# Duquesne Light Company

Subject: Beaver Valley Power Station, Unit No. 2  
Docket No. 50-412, License No. NPF-73  
Generic Letter 88-20 (TAC No. M74379)

ADDITIONAL INFORMATION FOR

BEAVER VALLEY UNIT 2 INDIVIDUAL PLANT EXAMINATION

FIGURE 8A-1. MINIMUM IGNITION ENERGY FOR HYDROGEN DEFLAGRATIONS  
(Taken from Reference 4)

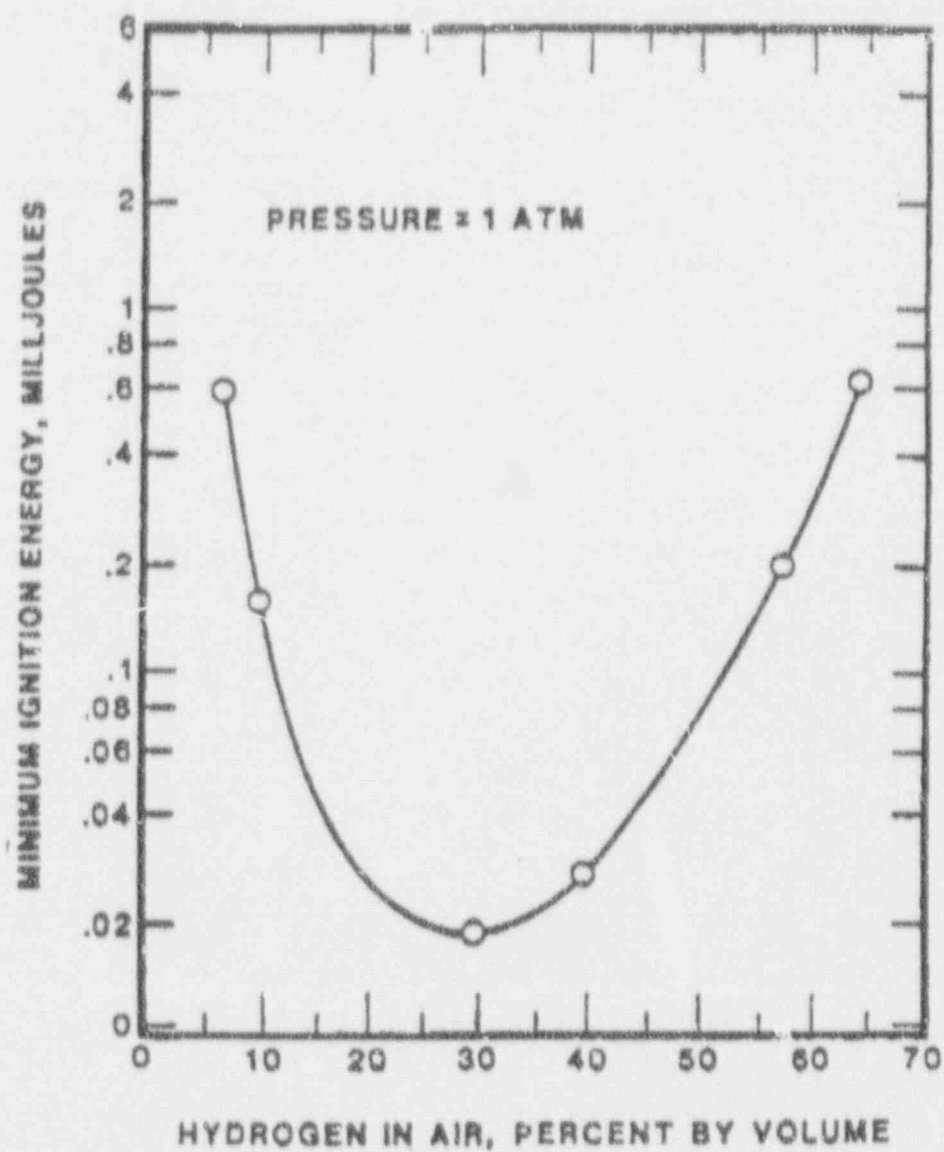
- Question 8. a) Provide a discussion of the ignition sources and limits used in the hydrogen combustion analyses. Were sensitivity studies performed to evaluate the impact on the IPE results, due to the uncertainties of the ignition limits used?

Minimum energies required to ignite various hydrogen-air mixtures are shown in Figure 8A-1 (taken from Reference 8-4). As noted in Reference 8-6, near-stoichiometric mixtures (approximately 30% hydrogen) can be ignited with spark energy levels as low as 0.02 milli-joules. However, the ignition energies required to ignite hydrogen mixtures increase substantially as the mixture concentrations approach the flammability limits. As noted in Reference 8-6, the energy required for ignition increases rapidly as the initial pressure is lowered. Conversely, the minimum spark energy decreases with increasing initial mixture temperatures. Reference 8-6 also notes that there is a degree of uncertainty associated with the magnitude of the available capacitive discharge electrical energy, which is actually expended in heating the gas near the electrodes. Measured ignition energy requirements for mixtures near the flammability limits appear to be very sensitive to the size of the vessel used in the experiment. One reported series of experiments indicated that the required spark energy to ignite a 4.5% hydrogen mixture was in the range of 10 to 100 joules, depending on whether the tests were conducted in a 240 ft.<sup>3</sup> vessel or a 10 ft.<sup>3</sup> vessel.

FIGURE 8-2. BEAVER VALLEY UNIT 2 CONTAINMENT BUILDING DIMENSIONS (SHEET 2)

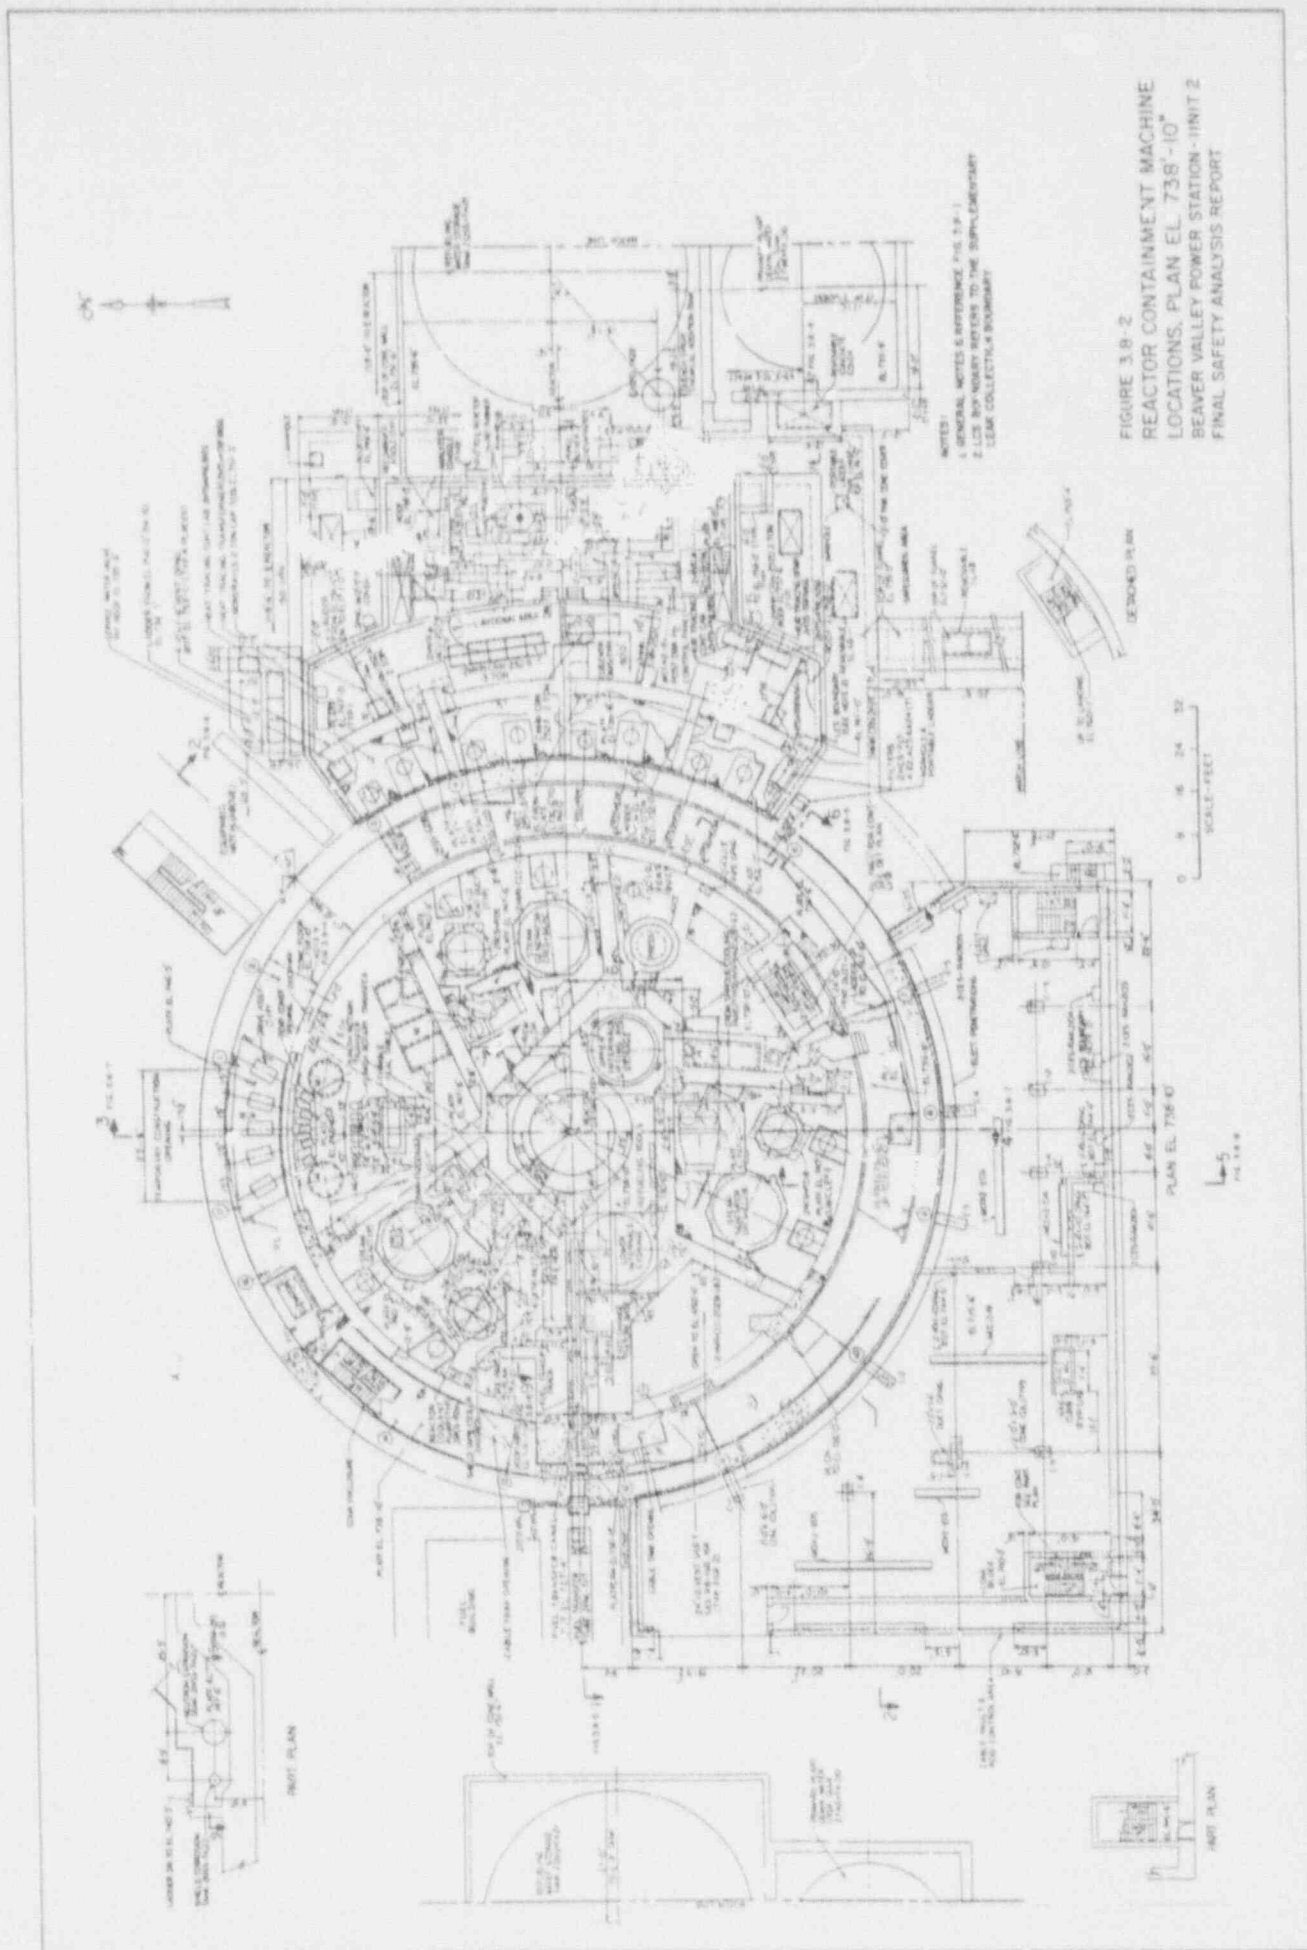
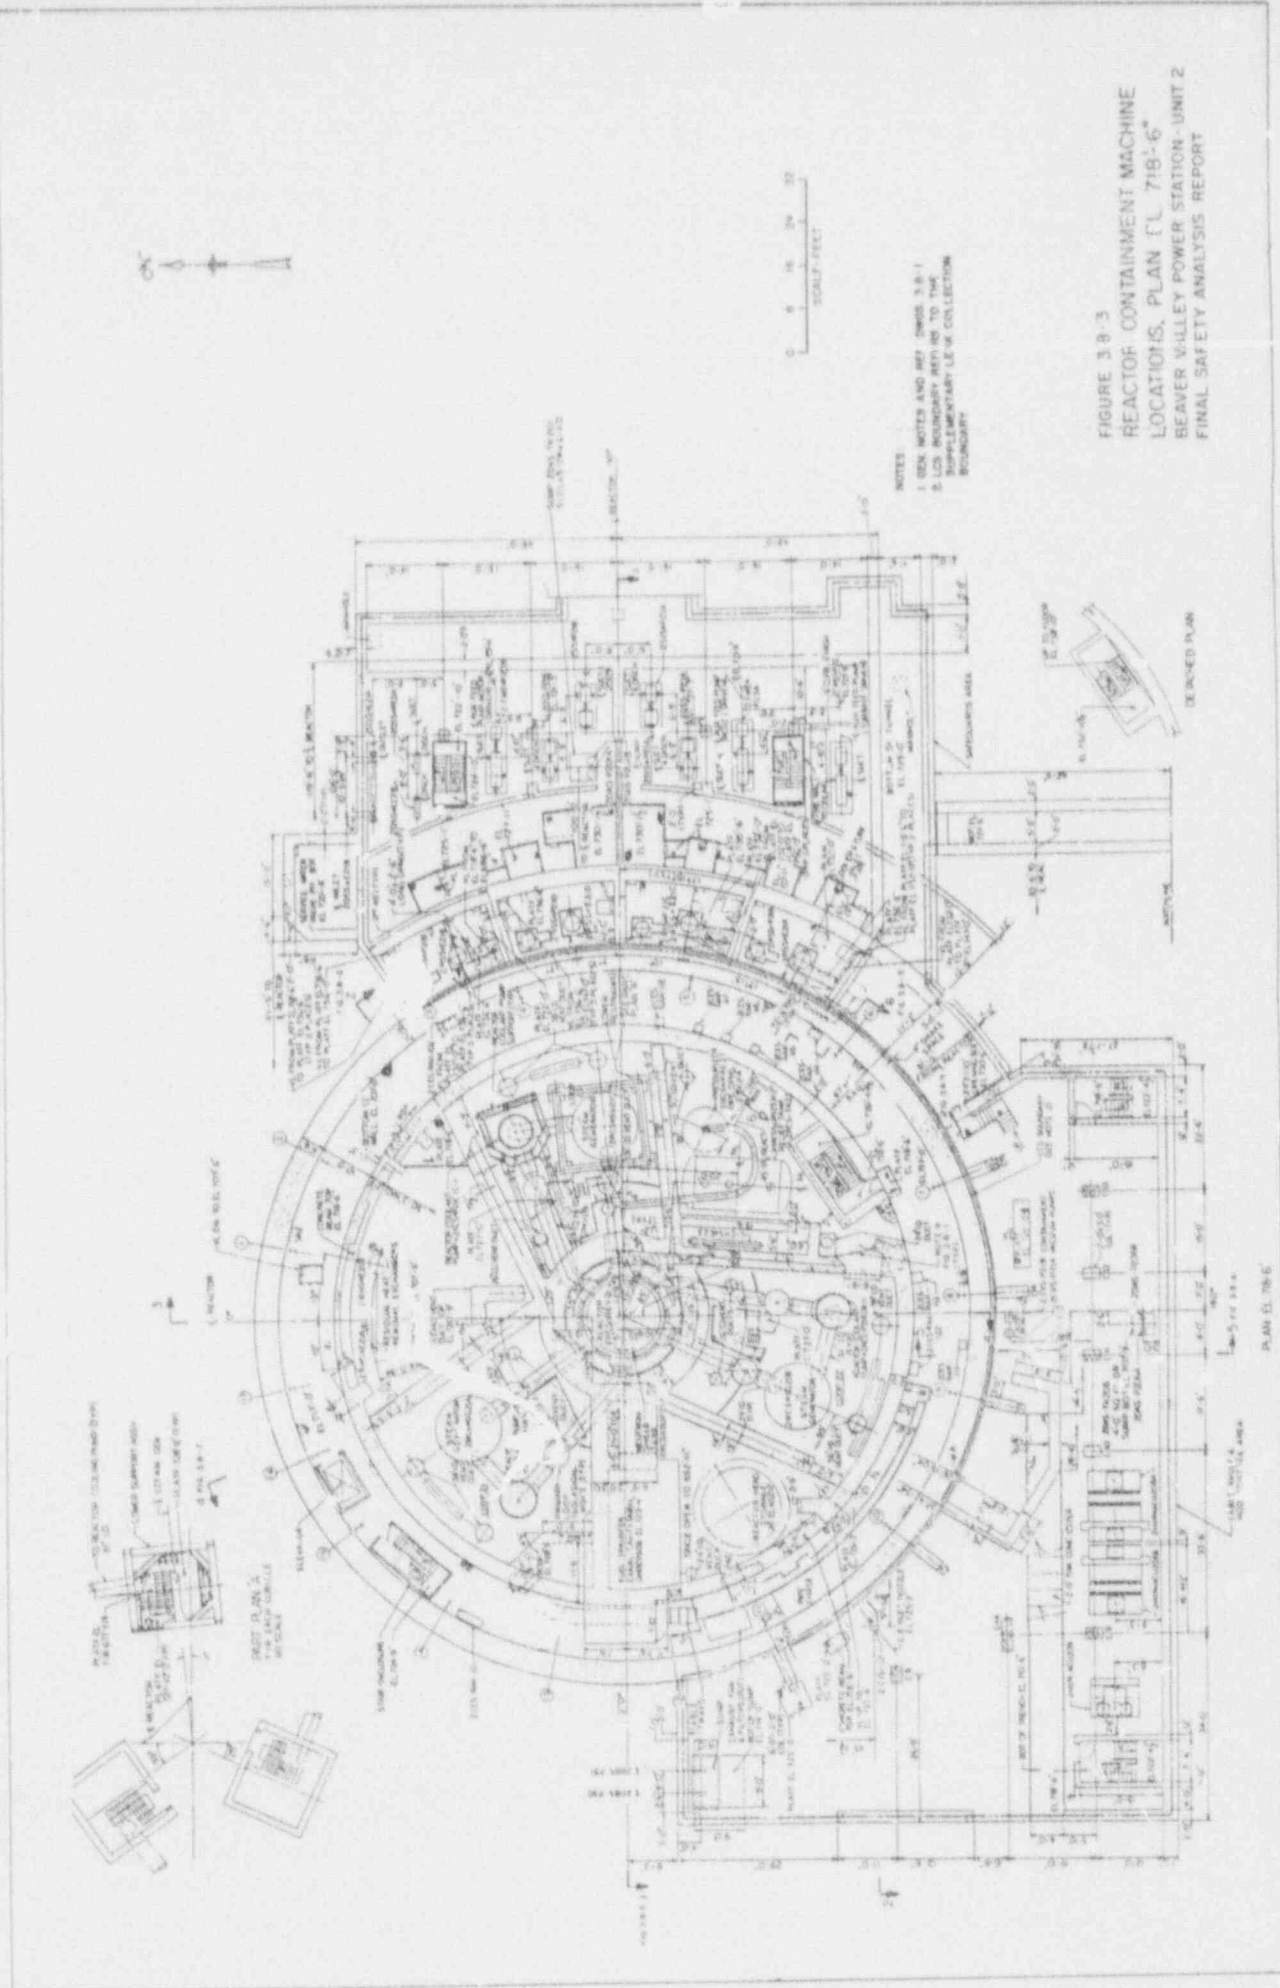
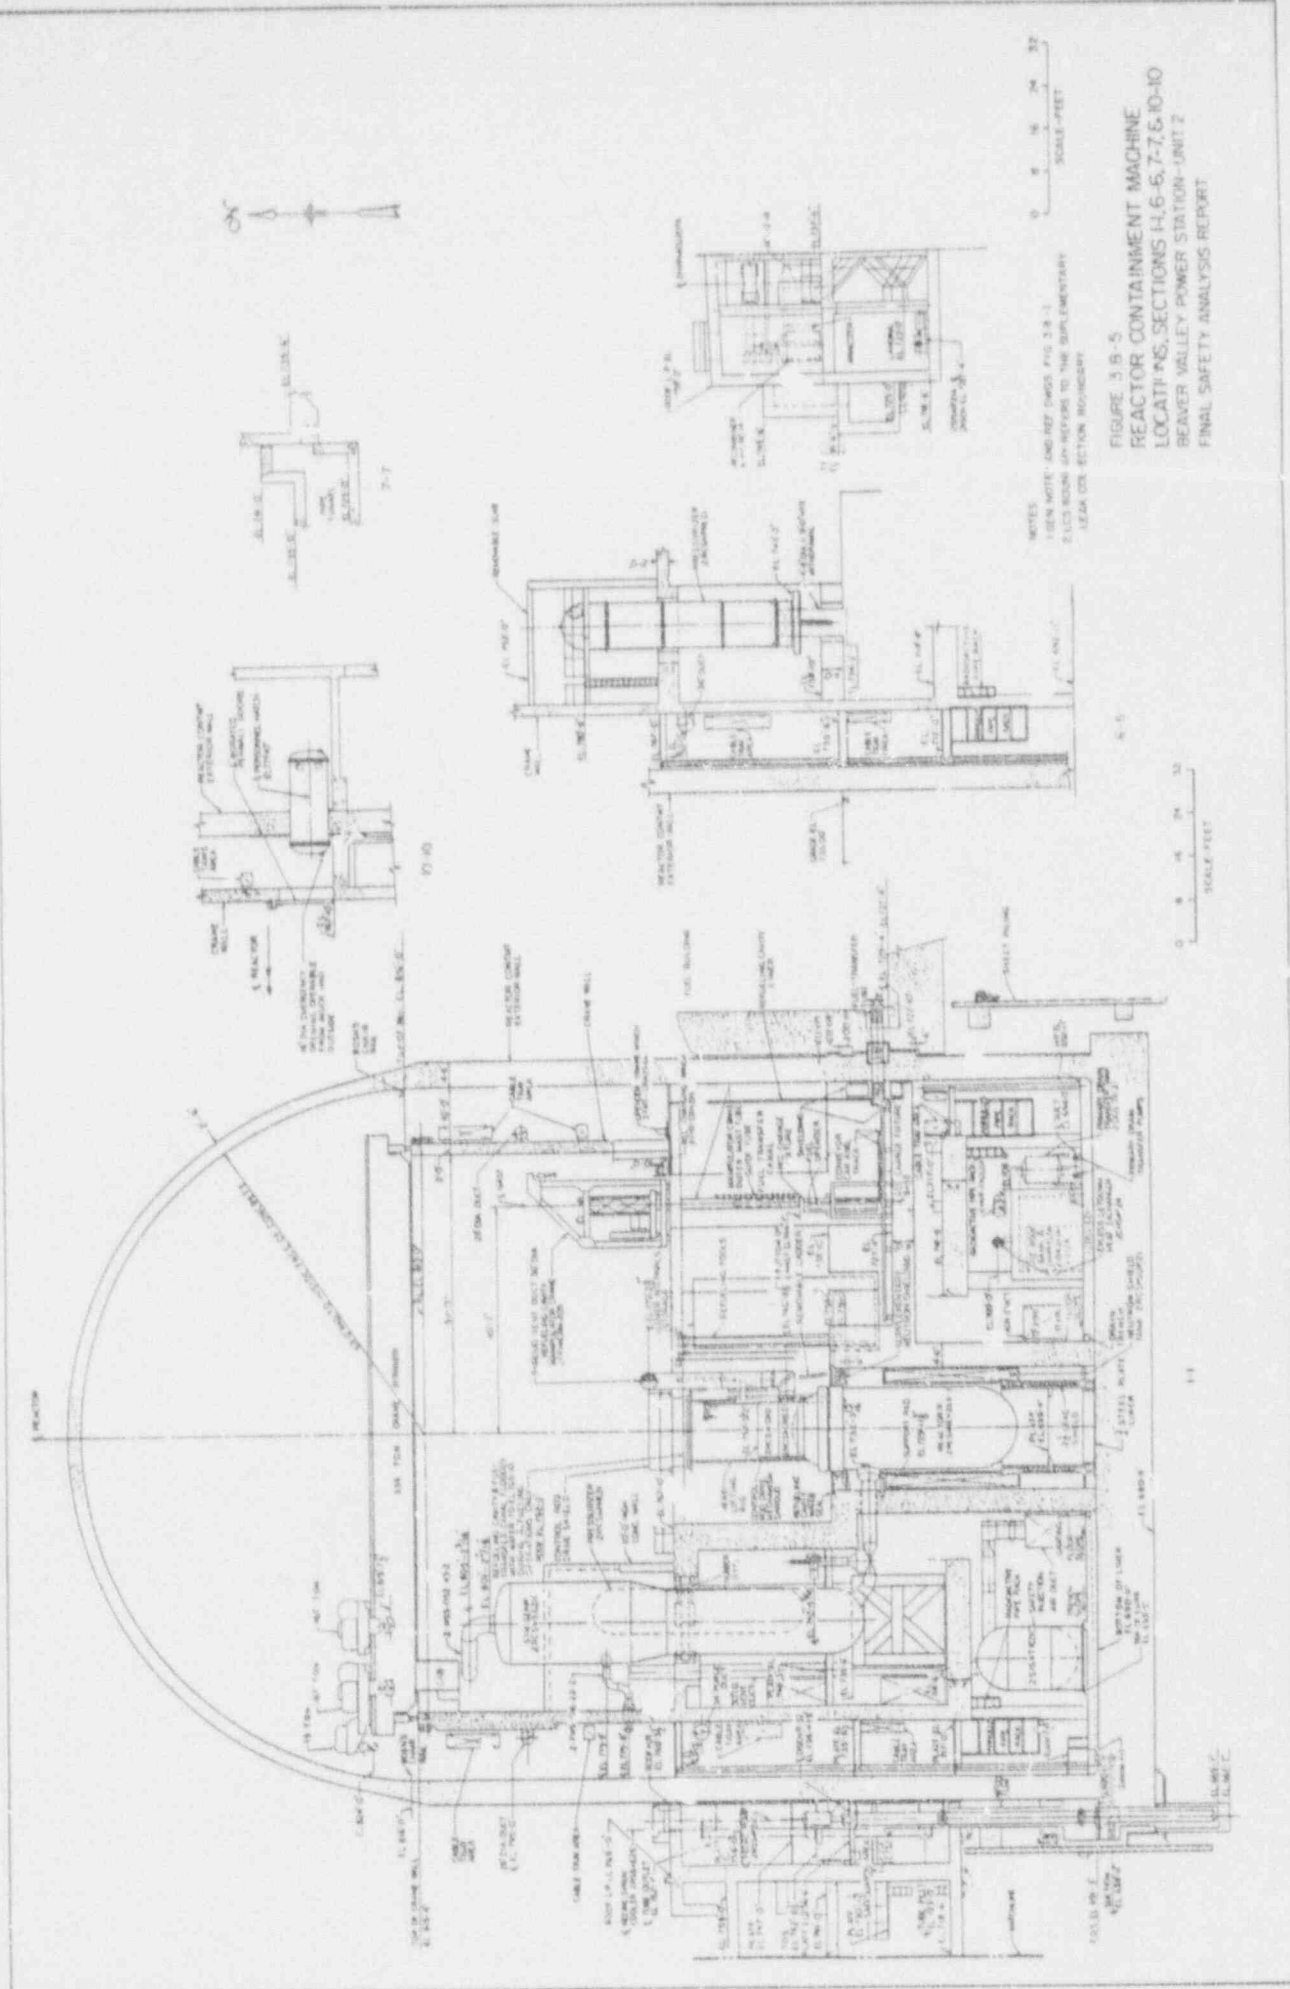
- b) Provide the information requested in NUREG-1335 (Section 2.2.2.1), i.e., accurate but simple representations of the containment showing the instrument tunnel, reactor cavity compartment, loop compartment(s), annular compartment(s) and upper compartment, with specific identification of potential reactor release points and vent paths indicated. Estimates of compartment free volumes and vent path flow areas should also be provided. Please address specifically how this information is used in the assessment of hydrogen pocketing and detonation.

- b) Attached Figures 8-1 through 8-7 provide dimensions of the Beaver Valley Unit 2 containment building. A simplified schematic of the BV2 containment, including compartment locations, compartment junctions, and potential break locations, is given in Figure 8-8. As shown in Table 4.1-1 of the IPE submittal, the total free volume of the BV2 containment is  $1.72 \times 10^6$  cubic feet. MAAP divides the containment free volume into four compartments. The current MAAP Parameter File for BV2 contains the following volumes for these compartments:
